A Avenue Landfill overview map

MAP OF SAMPLING LOCATIONS  
"A" Avenue Landfill Project  
Anacortes, Washington

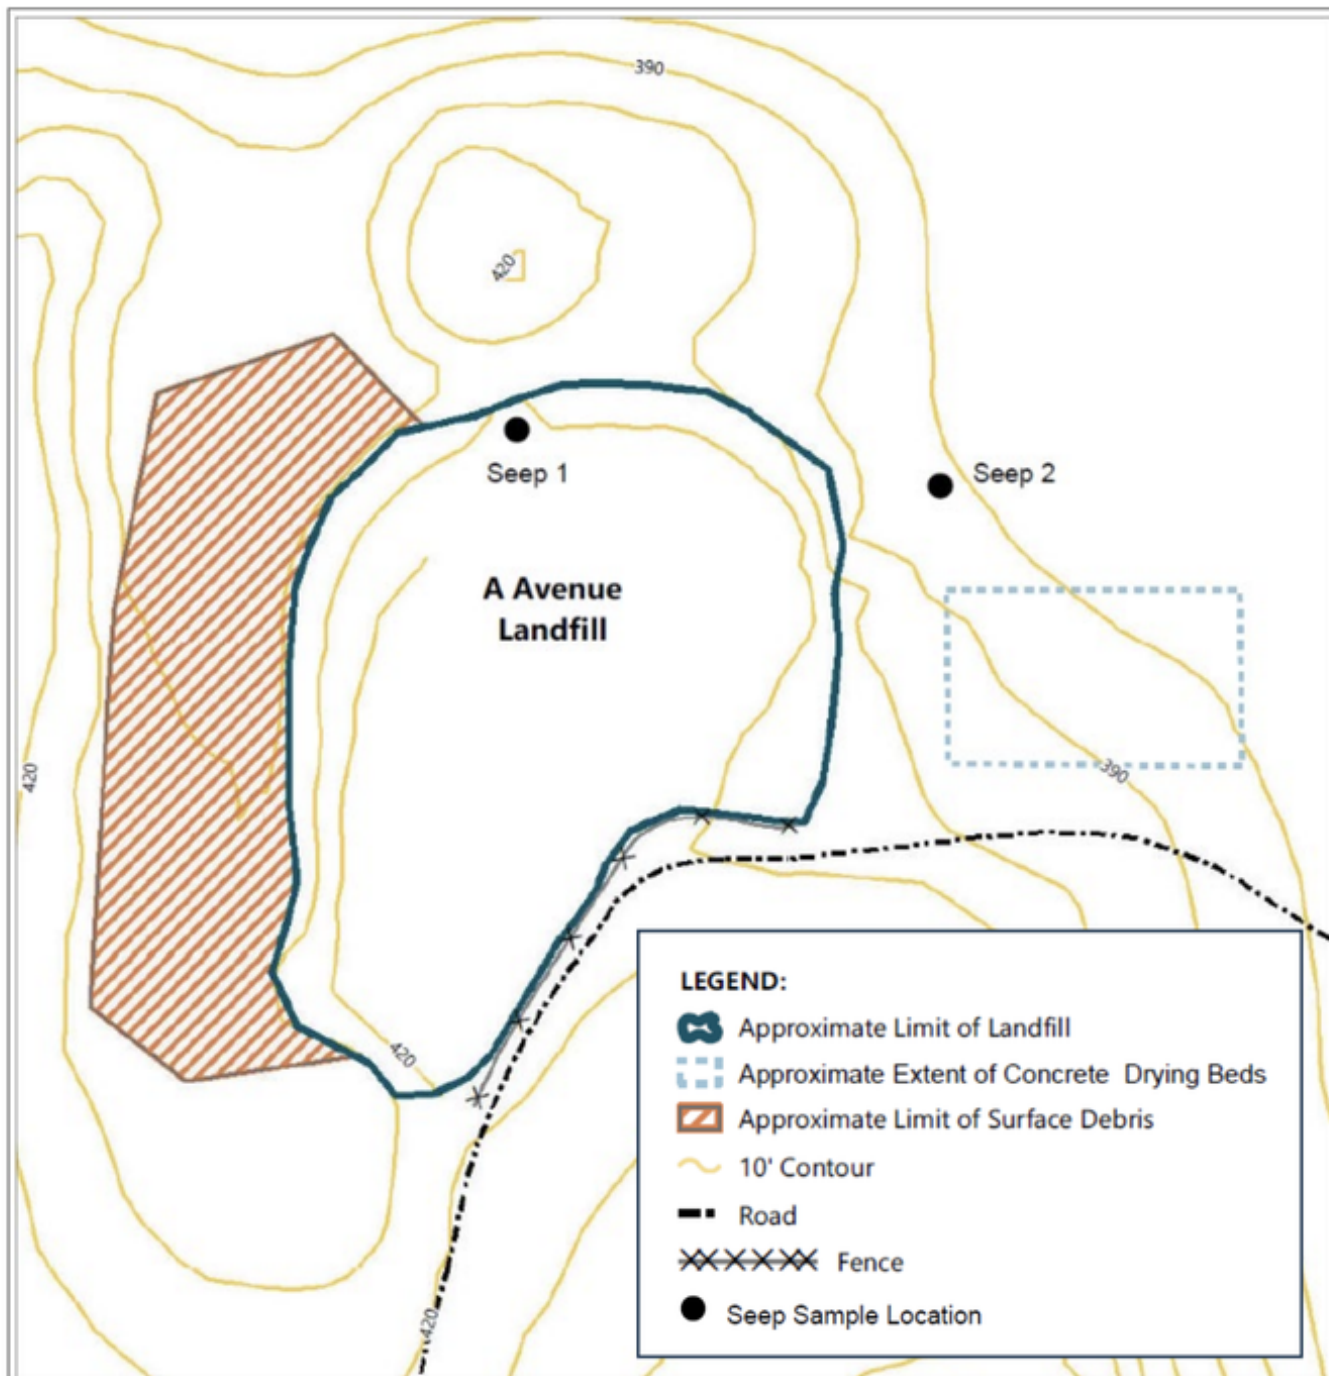
The overview map in the public factsheet for this site seems to have an error in the location of Seep 1. I've attached a copy of the map for the sample locations (originally from the 2003 Geomatrix Investigation Plan, but cited in the 2019 Field Report) which shows that the Seep 1 site is much farther to the west (in the area of the debris field) than shown on the current factsheet for this site. The site labelled as "Seep 1" on the current factsheet seems to correspond with soil sampling location S-4 from the 2003 work plan.
